**RE: Value Planning Study Final Report – Comox Valley Water Treatment Project**

# Value Propositions Implementation Response

# Value Planning Study

Alternative No.: IR-10

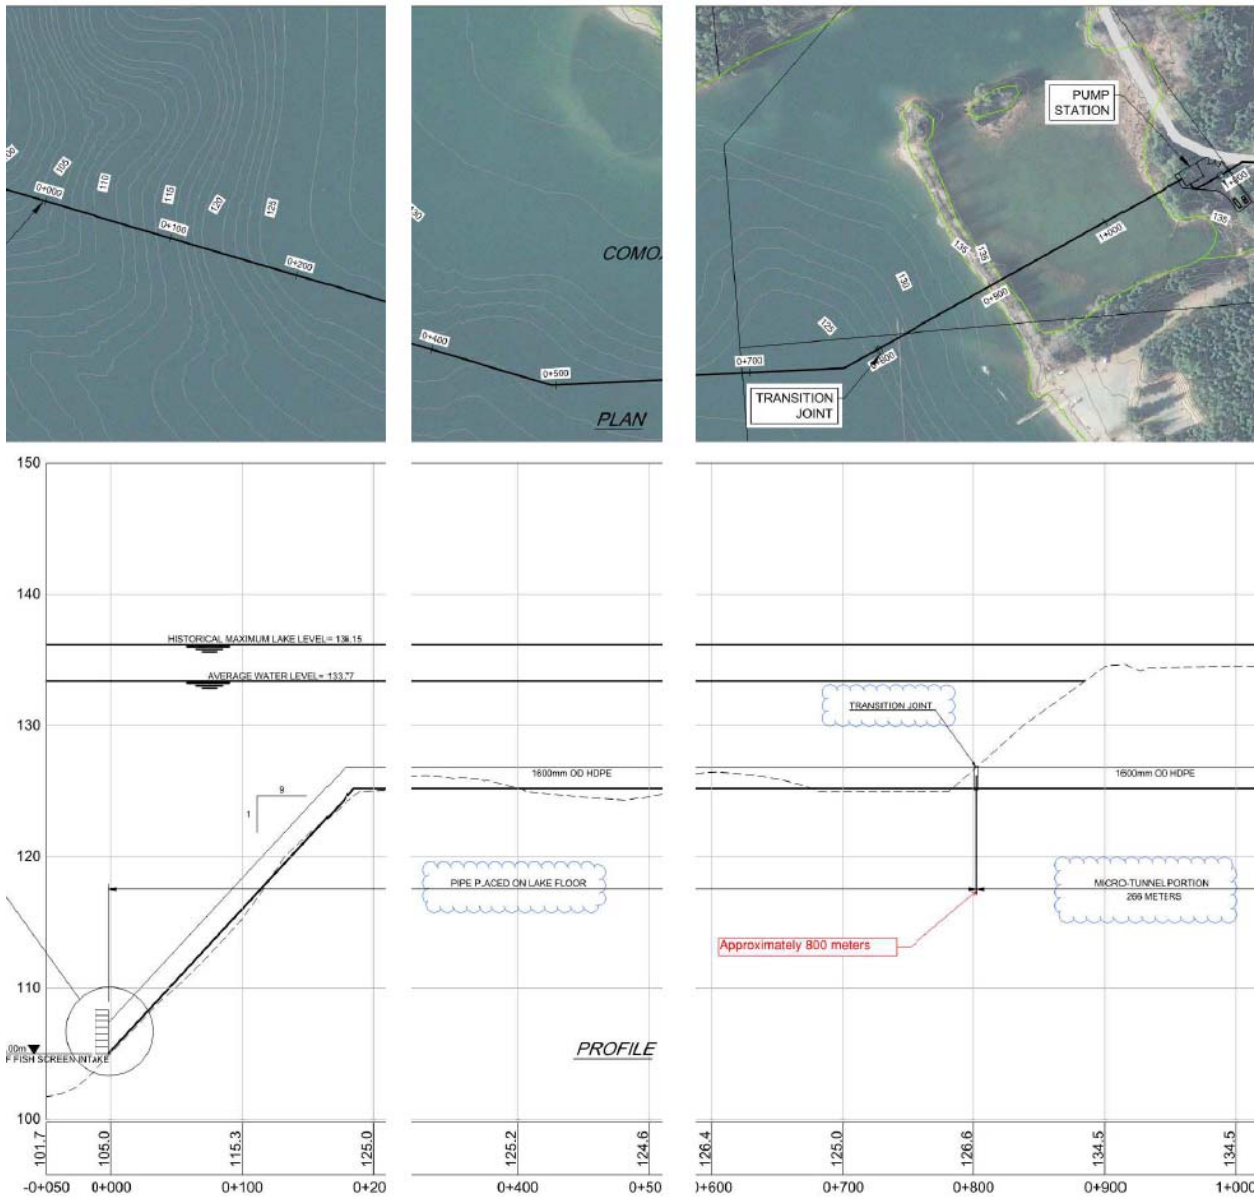
This will eliminate the need for the HDPE marine pipeline and ballast construction. Not constructing this pipeline and concrete ballasting sections will reduce the risk of creating turbidity plume in the lake that would result in another boil water notice.

Based on the water quality data and the fact that the raw water must be filtered, there does not appear to be justification for keeping the intake at EL105. Significant cost savings can be realized by raising the intake without appreciably affecting the plant operations or the treated water quality.

### 2.3.3. *IR-10 – Delete Marine Pipeline – Partial Accept*

This alternative moves the intake structure to the end of the tunnel section where the proposed transition joint is located. This will remove the HDPE marine pipeline and reduce project capital costs.

- It was also proposed to raise the lake intake structure to EL 120. However, the location showed in the value planning report is at EL 121. The shortening of the marine pipe and raising the intake has been accepted but the ground elevations will need to be confirmed before it can be finalized.

Alternative No.: IR-14

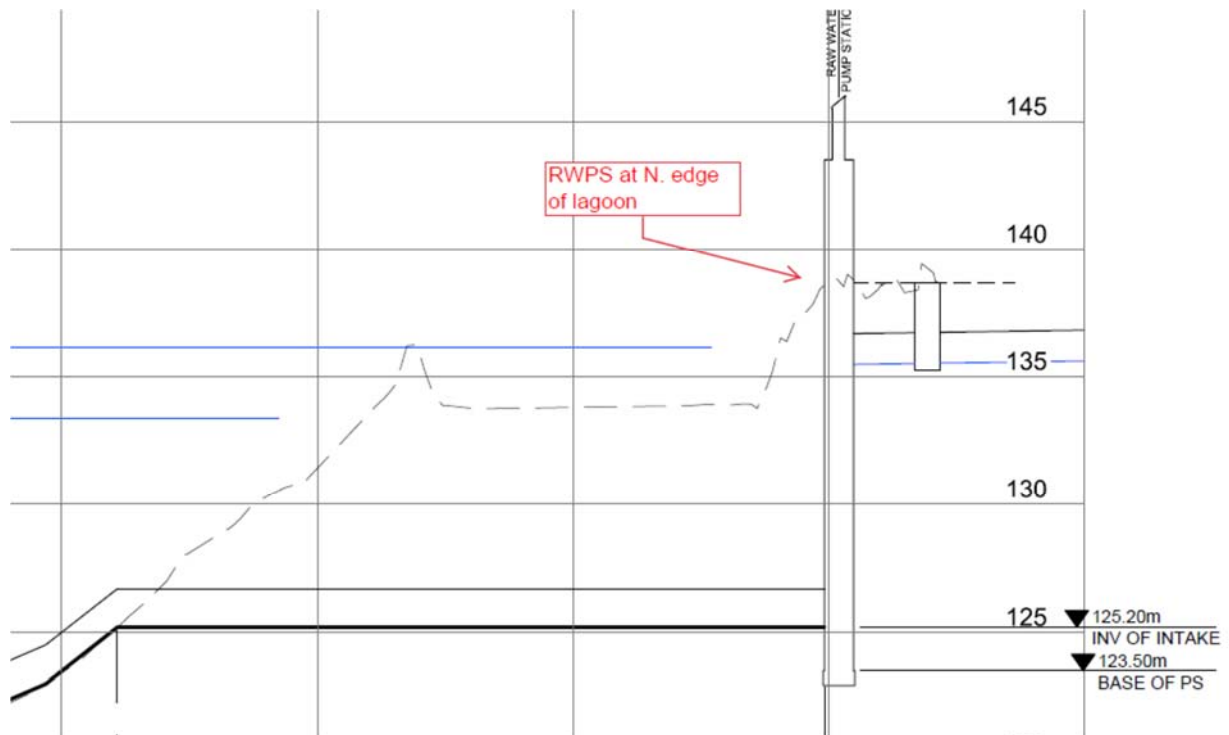
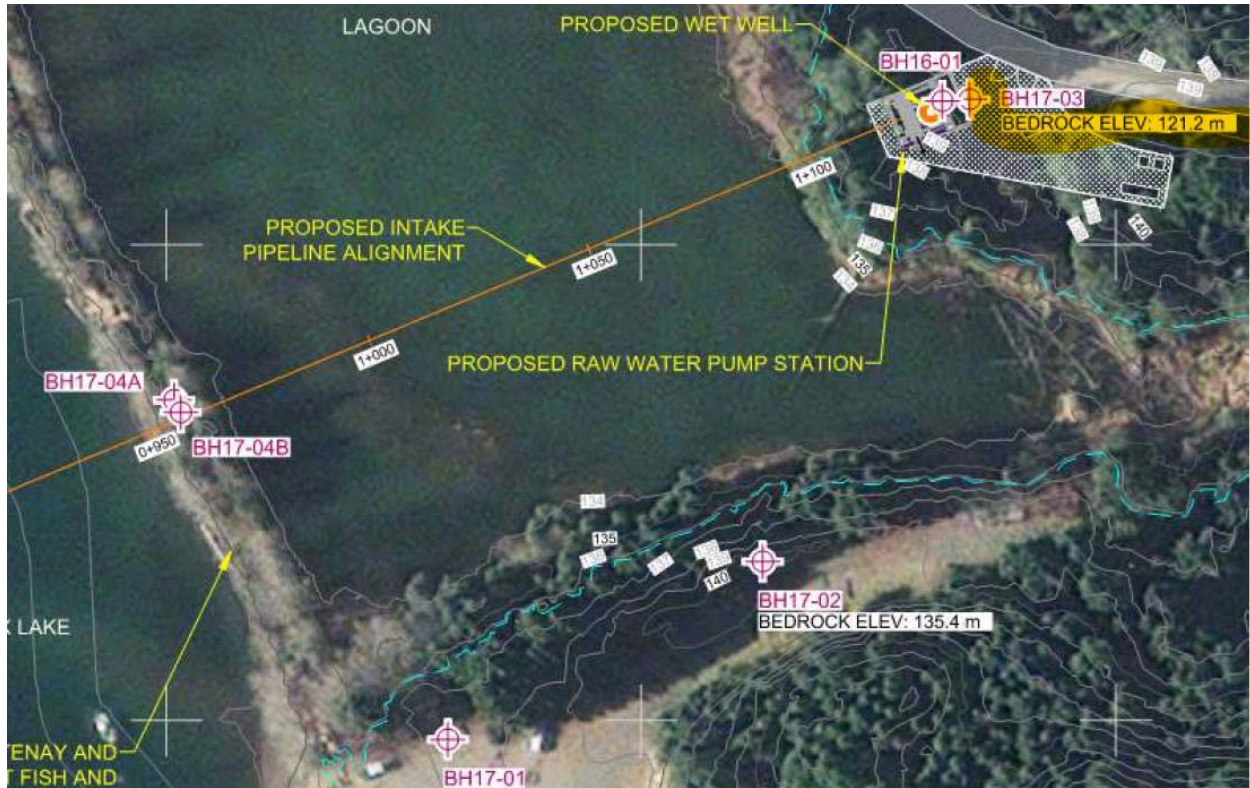
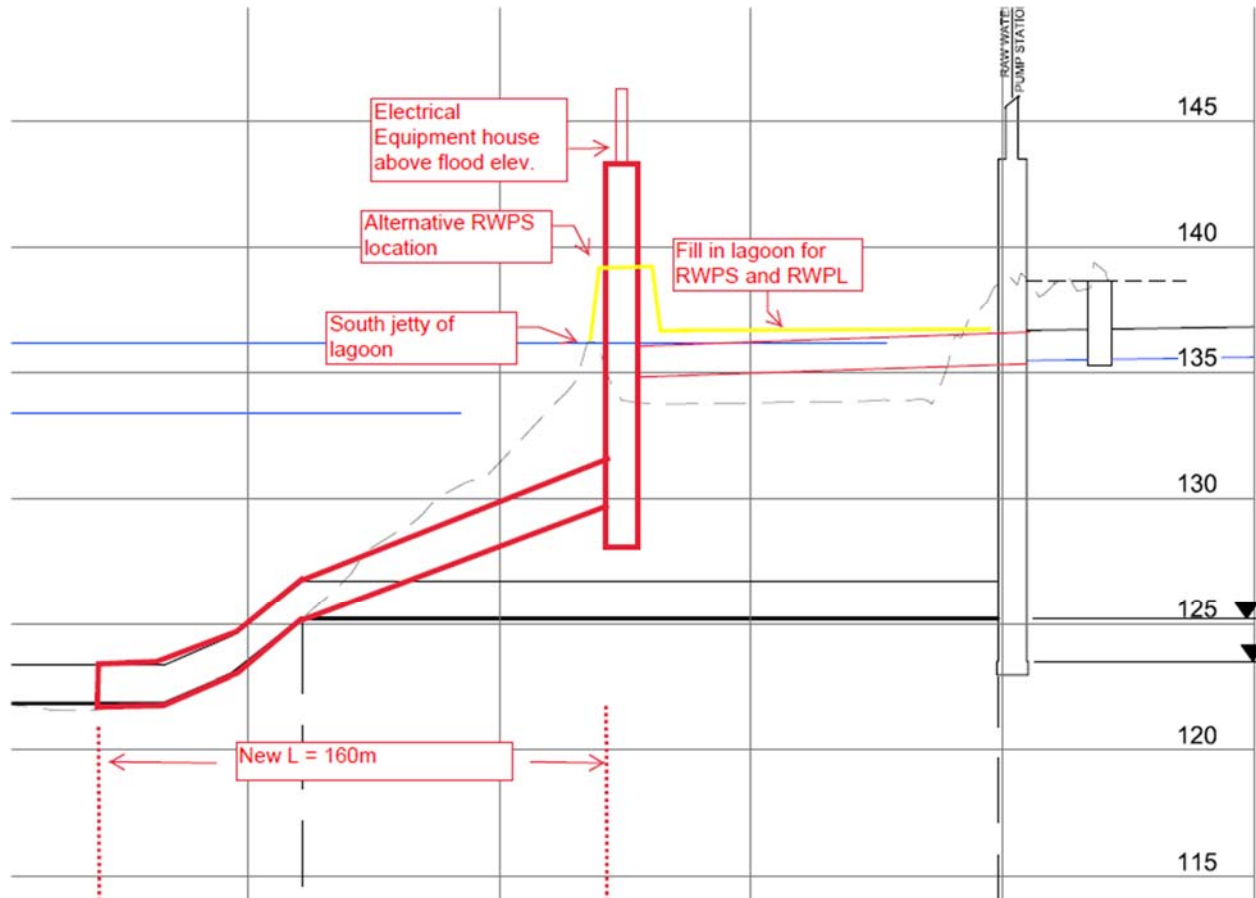
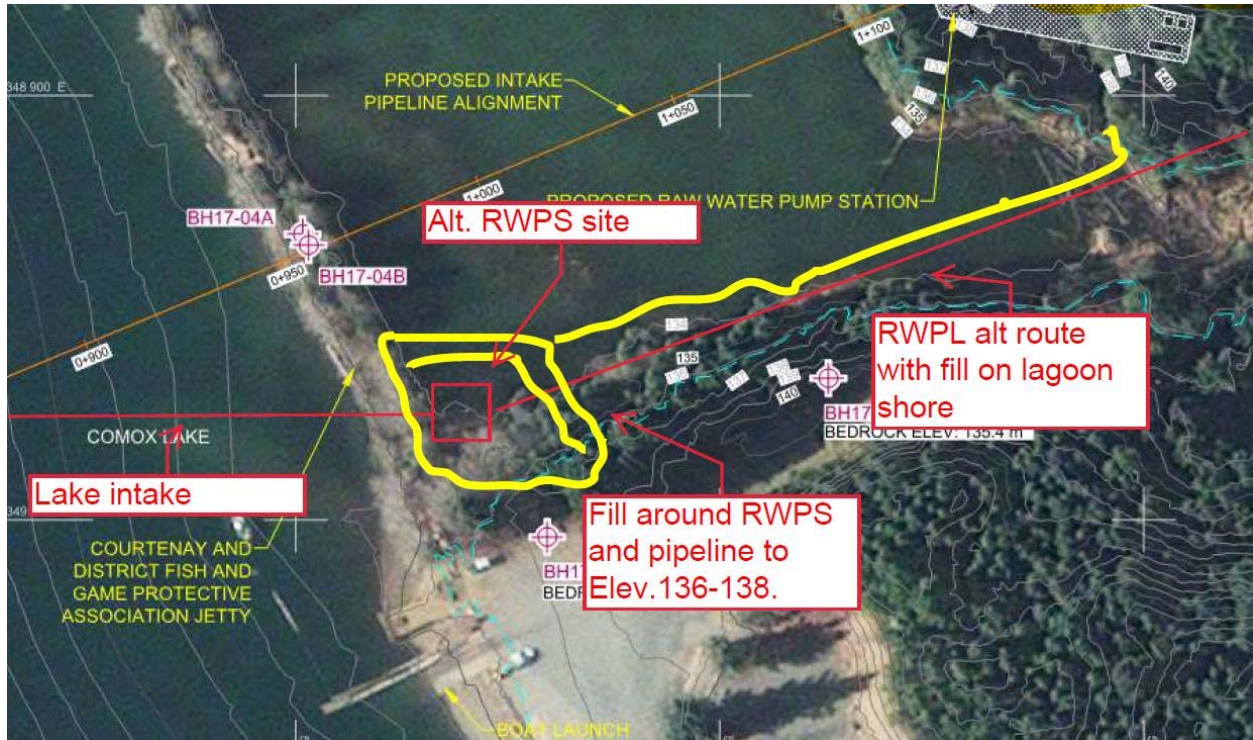
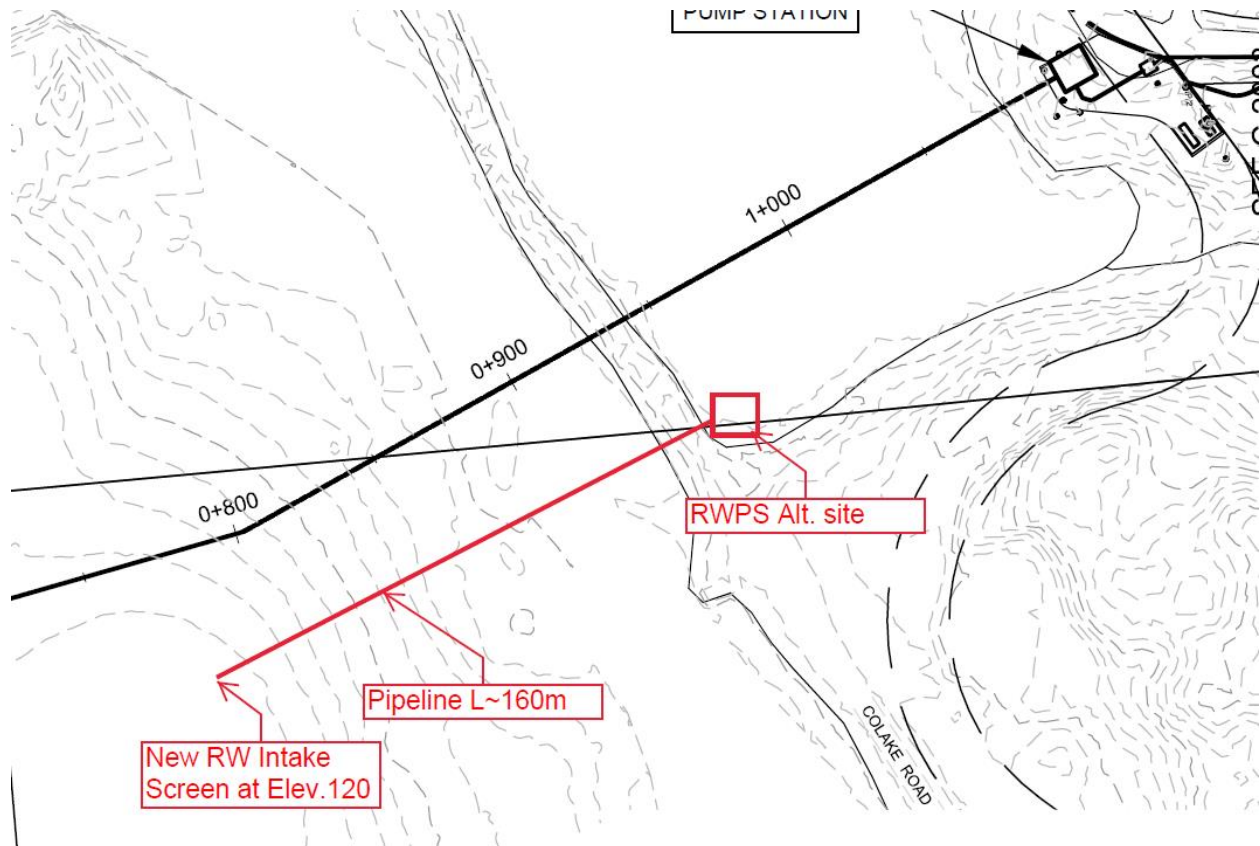
**Raw Water Pipeline.** The raw water pipeline is extended by about 150 m across the lagoon or very close to it, to reach the alternate RWPS site. The most direct route from the alternate site to the original is along the edge of the lagoon; this would require fill along the lagoon to accommodate the pipeline. Once the fill is in place, the access road for the pump station could be along this same alignment. The anticipated elevation of the roadway would be about EL138, or approximately 4.5 m of fill. Material excavated from the RWPS could be used for part or all of this fill.

- The value planning team also proposed to raise the RWPS invert level from elevation 125 metres to 129 metres. Elevation 125 metres was selected to ensure adequate submergence of the raw water pump impellers for the design minimum lake elevation of 128.93 metres (the sill elevation of the BC Hydro sluice gates) with allowance for 1.5 metres headloss from the intake structure to the RWPS wetwell (intake and frictional losses). With the reduction in length of the marine pipeline and subsequent decrease in friction losses, the invert elevation of the RWPS can be increased dependent on verification of the pump station hydraulics. Changing the design elevation of the minimum lake level is not accepted..
